Addendum 99 – UN Regulation No. 100

Revision 2 - Amendment 5

03 series of amendments – Date of entry into force: 9 June 2021

Uniform provisions concerning the approval of vehicles with regard to specific requirements for the electric power train

"Figure 1
Jointed Test Finger

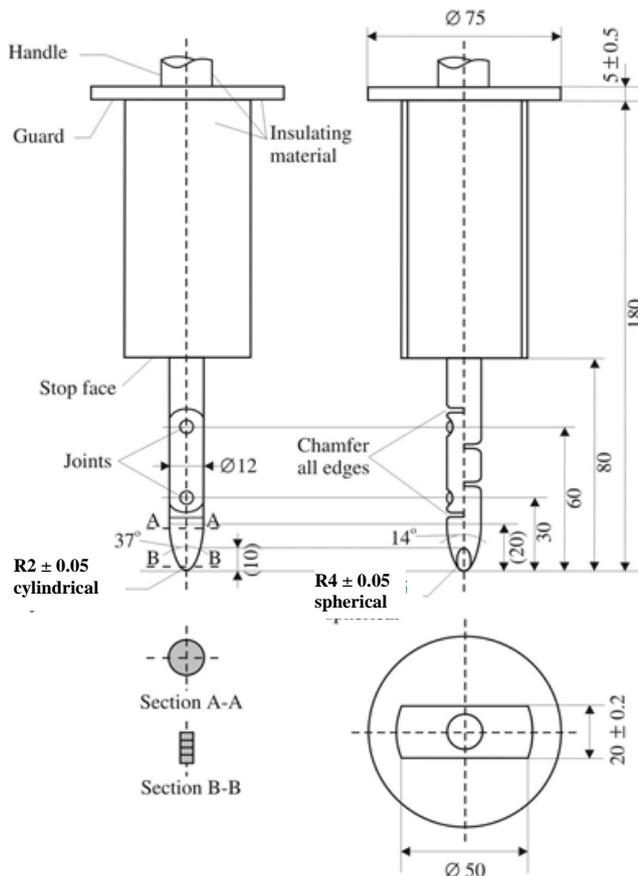
Figure 1, shall be deleted

Insert a new Figure 1, to read:

Material: metal, except where otherwise specified

Both joints shall permit movement in the same plane and the same direction through an angle of 90° with a 0 to $+10^\circ$ tolerance. "
